## Committee Report

Item No: 7C

Reference: DC/22/03231

Land North-West of, Church Lane, Barham, Suffolk

figure 2:  
**Example of gated alleyway**

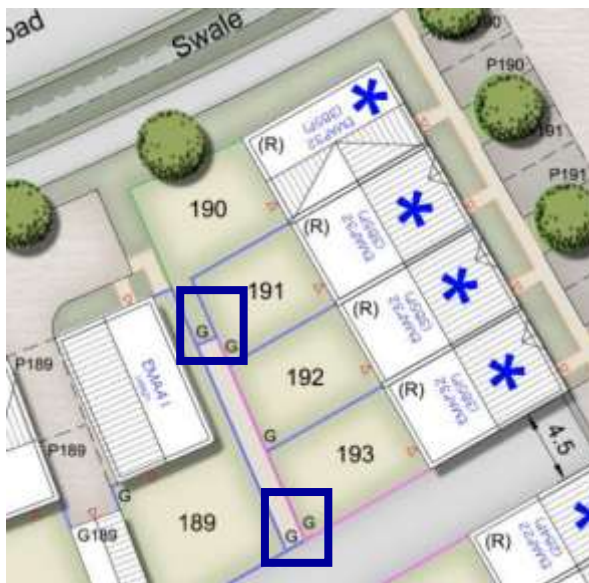
In trying to expand connectivity and facilitate good permeability and accessibility it isn't always possible to satisfy the designing out crime officer. Alleyways will all be gated.

figure 4:  
**Example of typical communal cycle store and binstore**

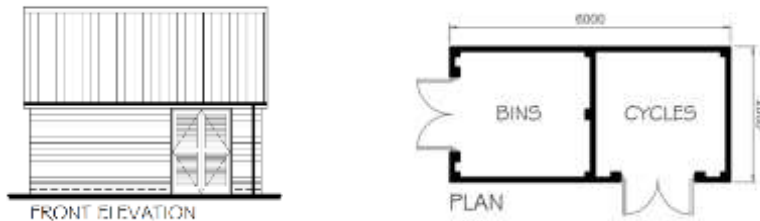
These will be surveilled from rear windows. The Council welcomes the provision of such stores as it supports modal shift. It isn't currently possible to encourage developers to incorporate integrated cycle storage within dwellings as it uses valuable floorspace.

figure 5:  
**sub-station design**

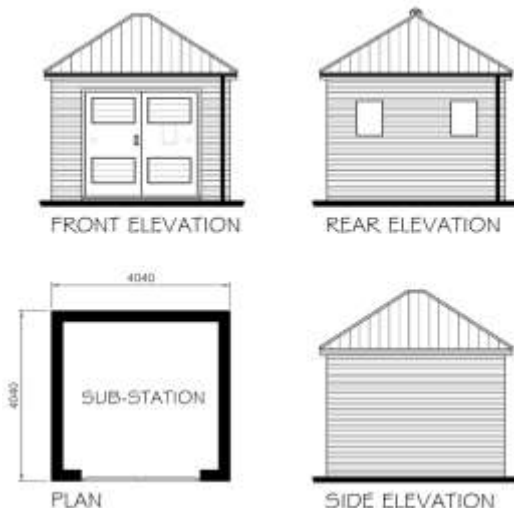
Sub stations will be a brick-built structure with a roof and further details of the pumping station will be required by condition

figure 15: **Proposed mix**

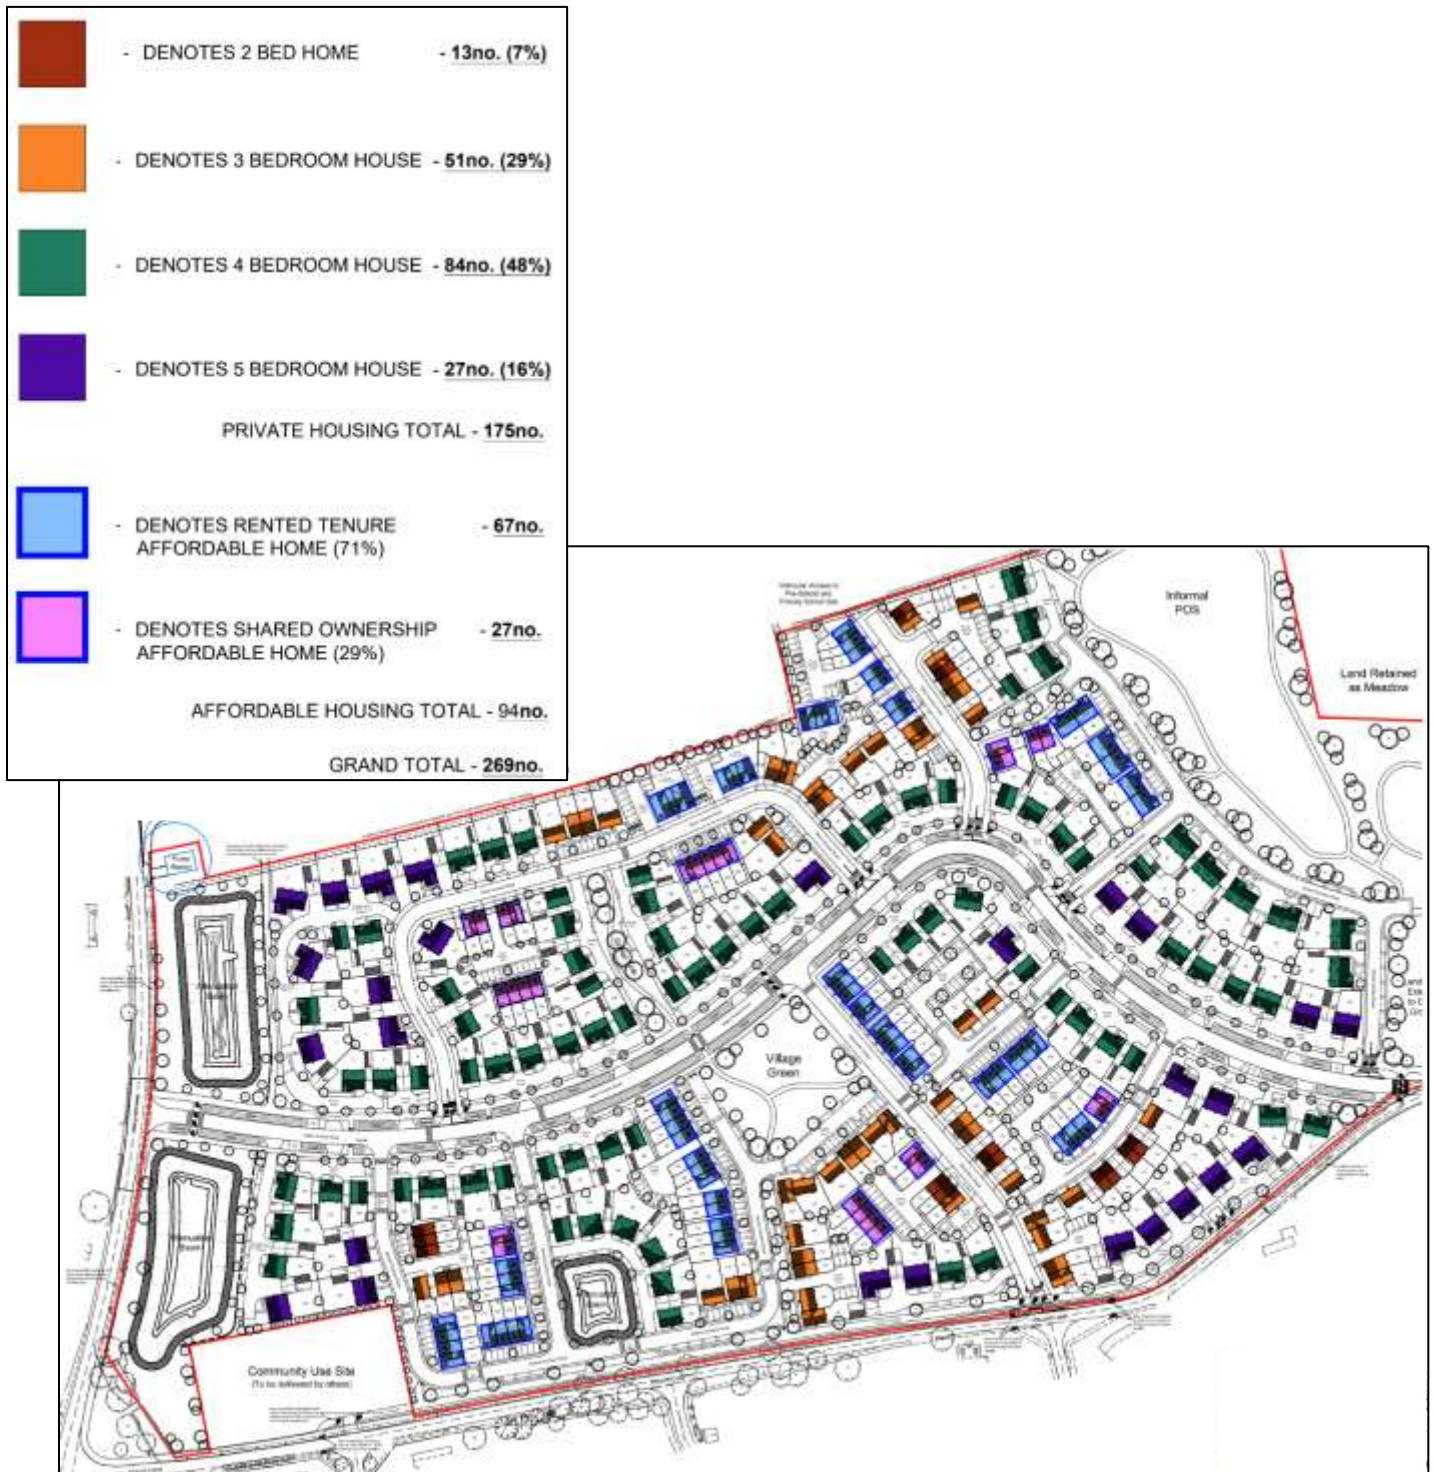
There is a broad range acceptable range of unit sizes across the site. The plan below shows the distribution of all the unit sizes.

figure 24: **Proposed storey heights**

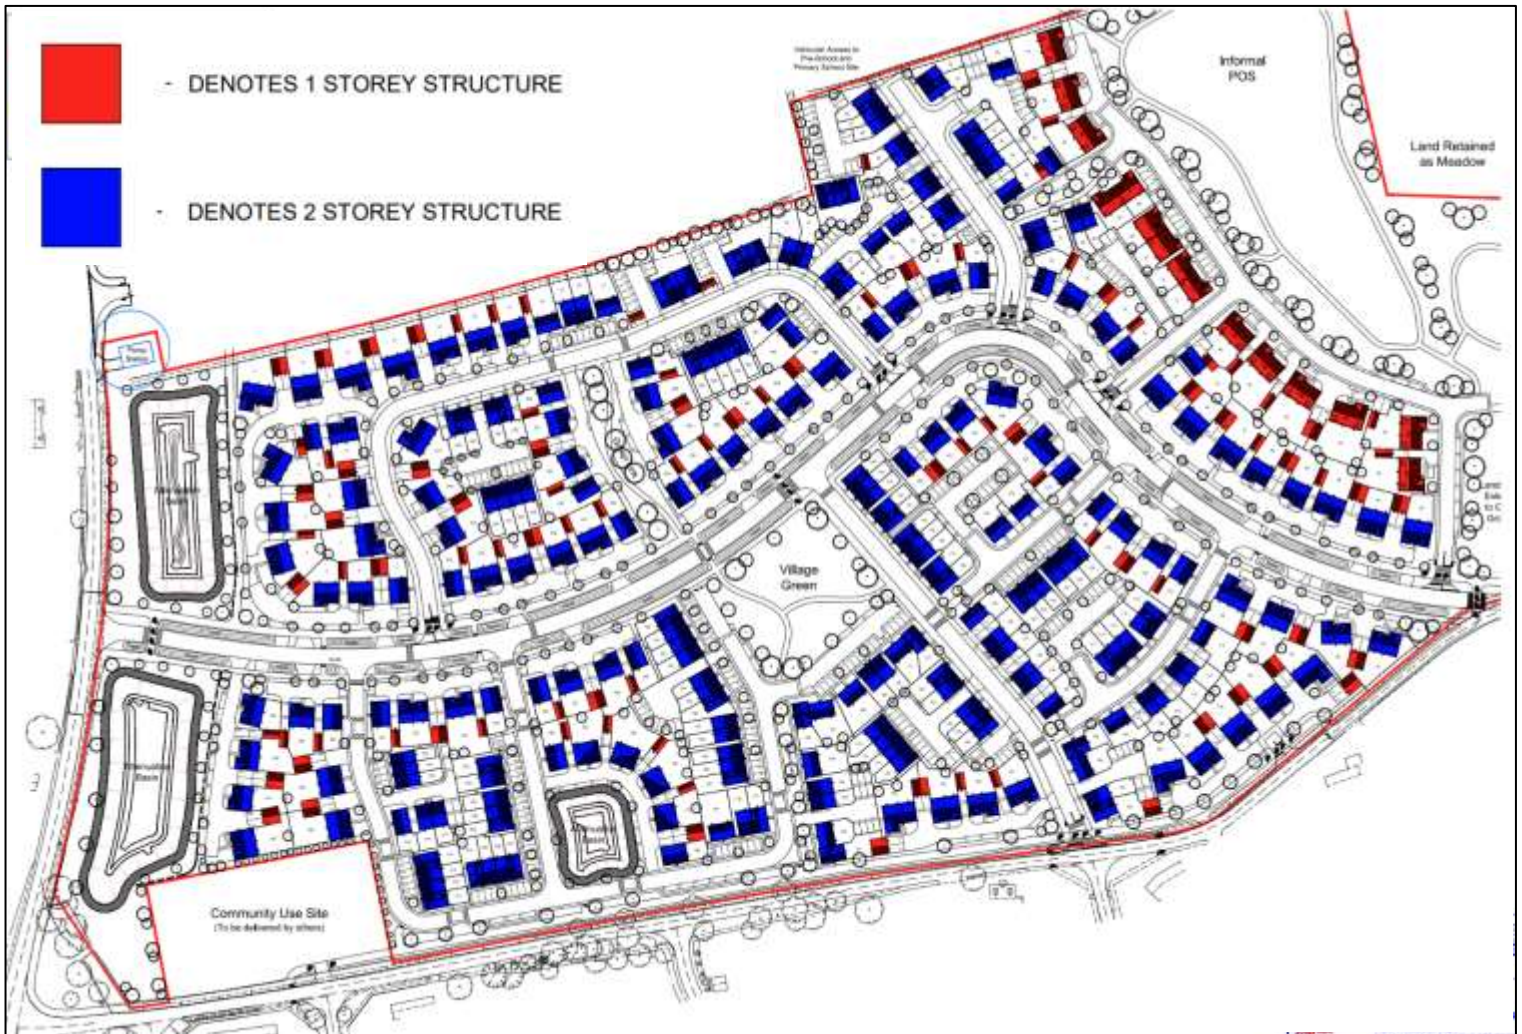
- 7.2 Scale expressed as the nature and pattern of storey heights across the site is acceptable.
- 7.3 In a welcome break from their normal practice Taylor Wimpey in a positive response to the Committee's desire to see bungalows within new developments has included 15 bungalows.
- 7.4 Overall the development comprises predominantly 2 storey dwellings which is entirely consistent with the scale of development hereabouts. There are no 3 storey or two storey + attic accommodation units within the layout.
- 7.5 The maximum two-storey height complies with the restriction added to the outline planning permission by condition.
